#### ADDENDUM 1 TO RFP 21-11

This addendum provides answers to questions submitted by prospective bidders. The University's answers are shown in RED.

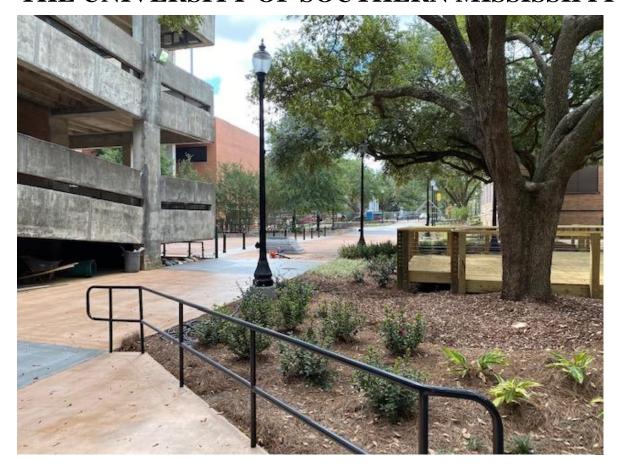
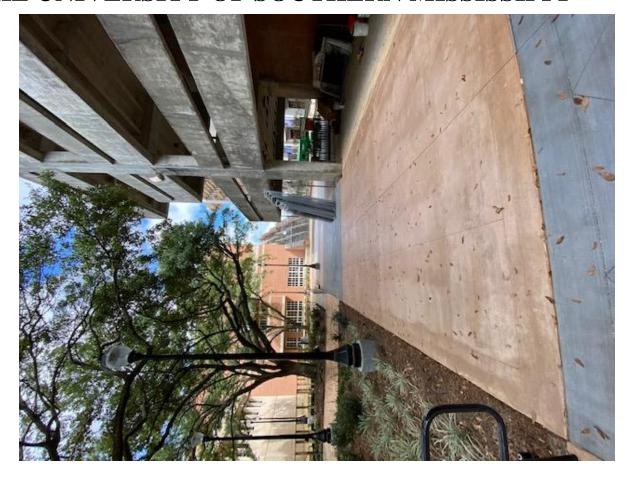
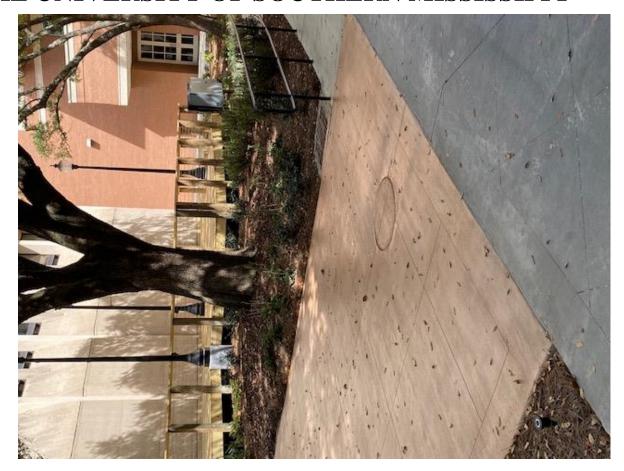
- 19. We will be submitting our proposal electronically. Are we still required to send one original sealed copy by mail? No.
- 20. Can you provide photos of approximate installation location? Photos of delivery location and a map from the delivery point to installation would be helpful also. Photos below.

The awarded vendor will be required to demo a small 24" circle of concrete 4" thick. Below this section of concrete is where both the power/data conduits and condensate drain for the kiosk are located. The power/data conduits contain pull strings only. The vendor will be required to demo existing concrete, stub up existing power/data conduits/condensate drain, pour back concrete to match existing colored concrete, pull all wiring from both the power/data panels, and mount new kiosk. Also, fulfill all other requirements defined within the specifications with implementation, mapping, functionality, and owner training.

The picture of the pavement with the circle cut in it is where the kiosk will go.
